2022MY BRZ

SERVICE INFORMATION BULLETIN

Fuel Pipe / Torque Specification Change

NUMBER: 09-93-22

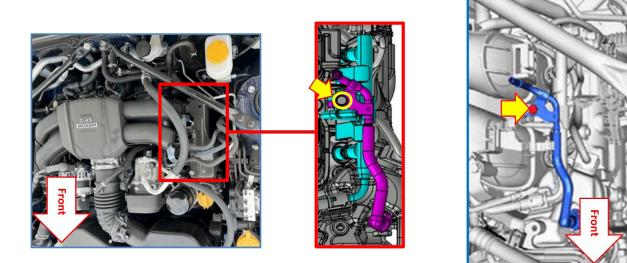
nces torque specification change for the fuel delivery pipe mounting bolt. The specification has been increased from 6.4 Nm to 9.0 Nm. Please torque to the new specification whenever mounting bolt removal is required. This change will be added to the Service manual in the future.

OLD Torque Specification	NEW Torque Specification			
6.4 Nm (4.7 ft-lb)	9.0 Nm (6.6 ft-lb)

When tightening the fuel delivery pipe mounting bolt, confirm the bolt is torqued to 9.0 Nm (6.6 ft-lb).
